ALERT SERVICE BULLETIN

Exchange of exhaust valves on ROTAX® Engine Types 915 i A, 915 i B (Series) and 914 (Series)

Exchange of exhaust valves on ROTAX Engine Type 915 i A, 915 i B (Series) and 914 (Series).

Fig. 2
Identification of exhaust valves

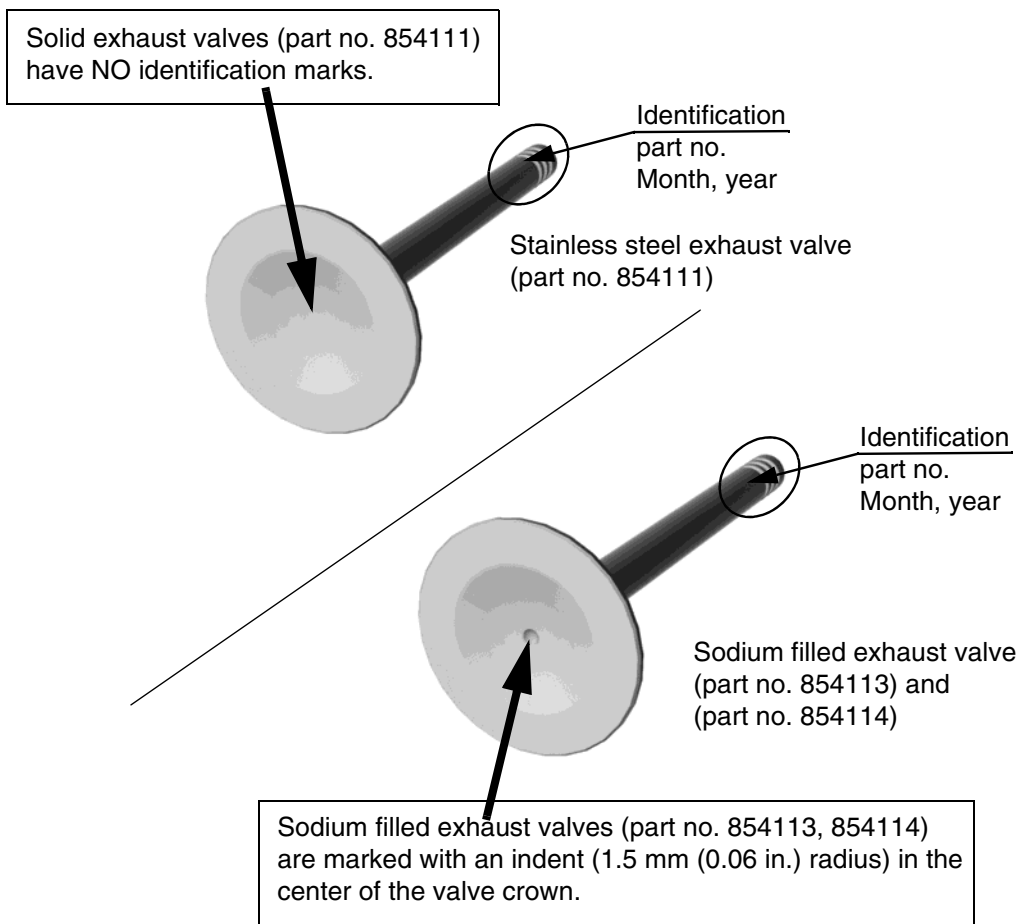
Exchange exhaust valves part no. 854113 for part no. 854114 in accordance to relevant Maintenance Manual Heavy.
